MICHIGAN DEPARTMENT OF
ENVIRONMENT, GREAT LAKES, AND ENERGY

National Remedy Review Board

OU5 Area 4

Allied Paper Inc./Portage Creek/Kalamazoo River Superfund Site

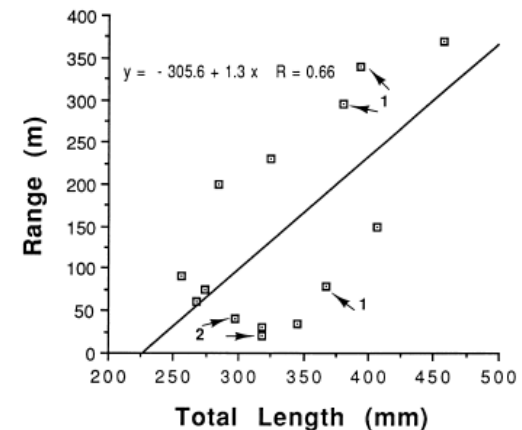
- RAO1 and RAO 2 utilize resident SMB as the receptor.
 - YOY: 79mm to 119mm
 - Adult 254mm to 356 mm
- No site-specific studies have been conducted to look at movement of SMB within the Superfund site and a “homerange” has not been considered or developed for SMB.
 - Literature suggest the SMB movements in riverine systems is generally limited- with “home ranges” on the order of tens to hundreds of meters- and SMB may respect stream features as boundaries.
- Two RAOs proposed for Area 4 (RAO 1 and RAO2) utilize resident fish (adult and young-of-year smallmouth bass) as the receptor, both RAOs are achieved through removal of contaminated sediments and attainment of the 0.33 ppm PRG for TPCBs.

Figure 9. Natural neighbor interpolation of Aroclors for combined RI and SRI data in Area 4 floodplain surface sediments. model was 54.6 acres based solely on the uncorrected SRI data.

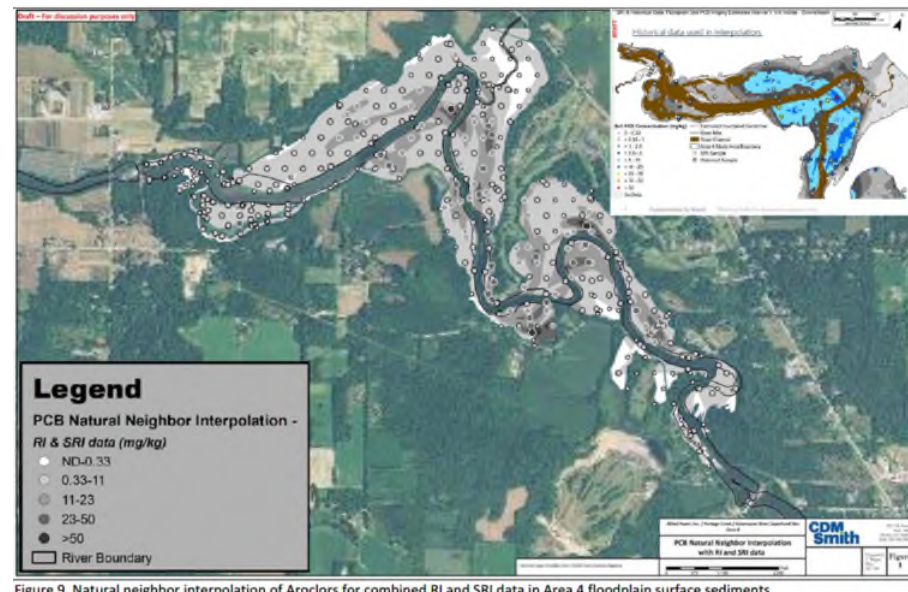
- TPCB Remedial Footprint
 - Ordinary Kriging (OK) and Natural Neighbor (NN) models were applied to the SRI-only and RI+SRI data
 - RPs expressed desire and plan to censor or qualify existing RI-dataset during FS/RD which would either remove or artificially bias approximately 25% of the data set collected and relied upon within Area 4, which was almost exclusively collected by RPs.
 - EGLE's analysis identified fundamental flaws in the underlying OK statistics and our position is that model should not be relied upon for decision making.
 - The NN model is more likely to accurately represent field conditions because it preserves short scale continuity.

**Kalamazoo River Area 4 ASTM
Acres above Total TEQ
Threshold, Mammalian 0-12"**

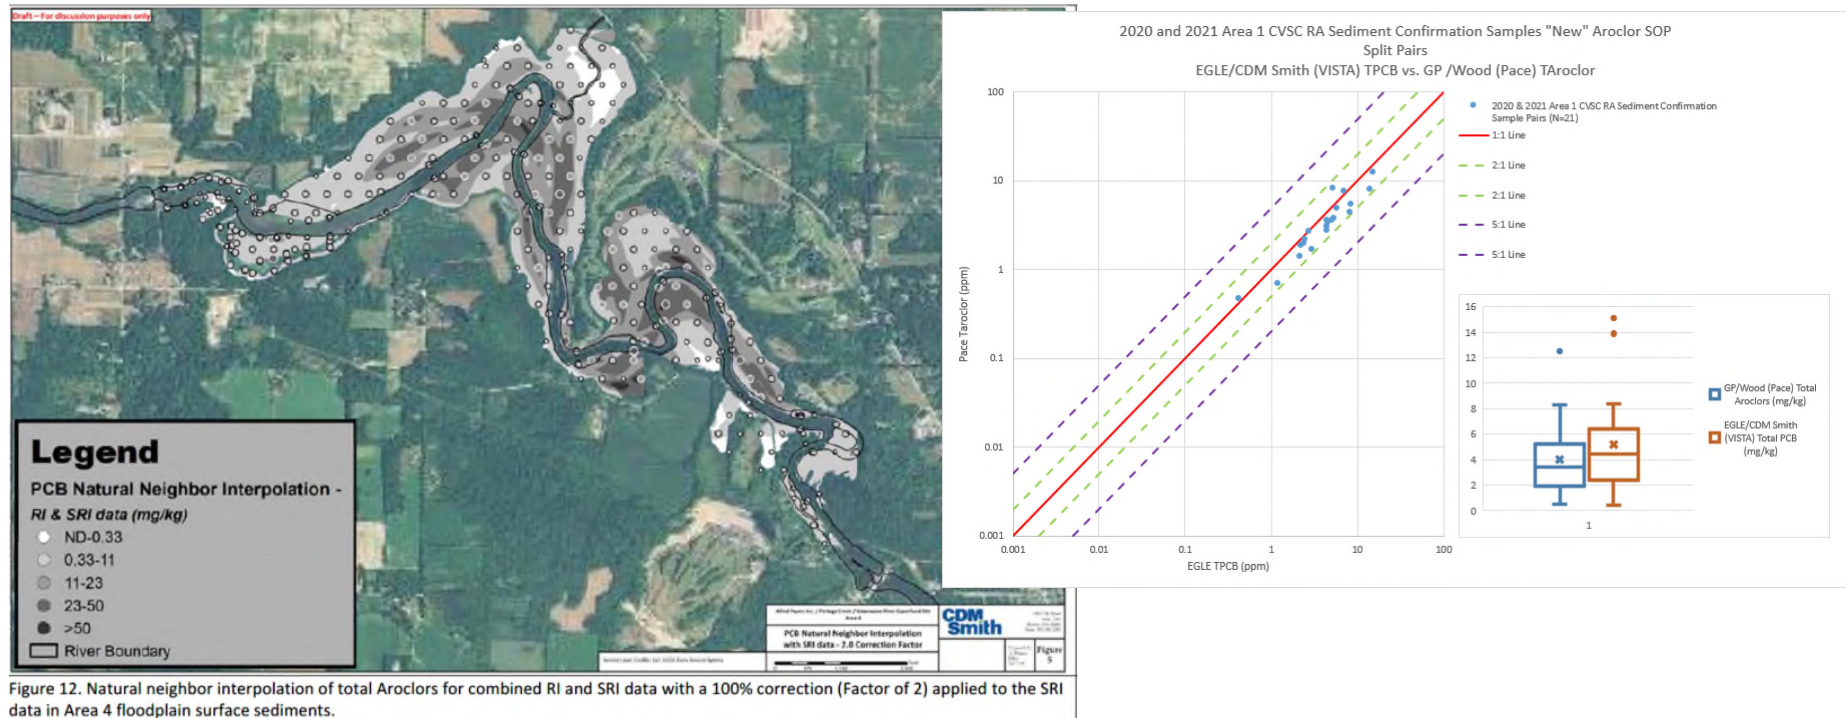
- The SRI and ASTM use a limited number of sample locations (55) to interpolate TTEQ concentrations over an area of more than 489 acres.
 - The approach being applied refuses to acknowledge that that sparsely sampled TEQ values can be leveraged by exploiting the relatively strong ($R^2=0.91$) relationship between TEQ and PCBs which were measured at much more dense spatial scale.

- The FS should provide evidence of the assumed spatial correlation in TEQ measurements is adequate to support the interpolations, and there should be a quantitative evaluation aimed at estimating the uncertainties in the mapped footprints based solely on the TEQ measurements versus those based on a combination of measured TEQs and estimated TEQs based on tPCBs.

- Data could also be integrated using co-kriging
